AGENDA TITLE: Contract Change Order No. 2 - DeBenedetti Park/G-Basin Project Design

CONTRACT CHANGE ORDER NO. 2

PROJECT: DeBenedetti Park Design Project

DeBenedetti Park

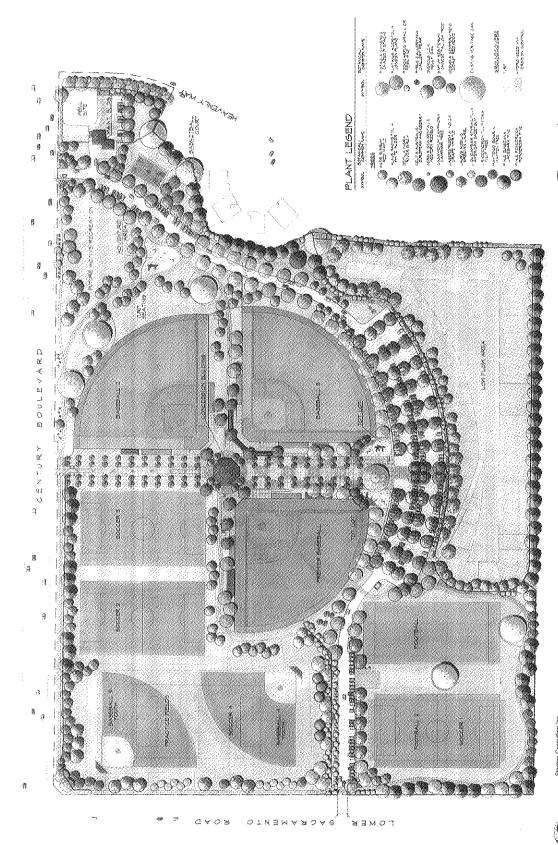
Attached is the concept plan for the project which was approved by Council. The change order which is attached will benefit the project in several ways. They are:

• The low flow area will be expanded to the west and one football field will be eliminated. This expansion of the low flow area will allow for a dramatic increase in water storage. Other athletic field surfaces will benefit due to less flooding. This will also allow for several retaining walls to be eliminated from the project design. Although this change to the project will also result in two trees being removed it is recommended due to the benefits to the overall project.

• The project design change will result in several athletic fields being built at grade (on high ground). Some re-positioning of the field features will also occur which will allow for walkways and turf areas to blend well with anticipated street improvements. As design work submittals of 50% completion have occurred, the change order will include adjustments to plans prior to the 90% submittal.
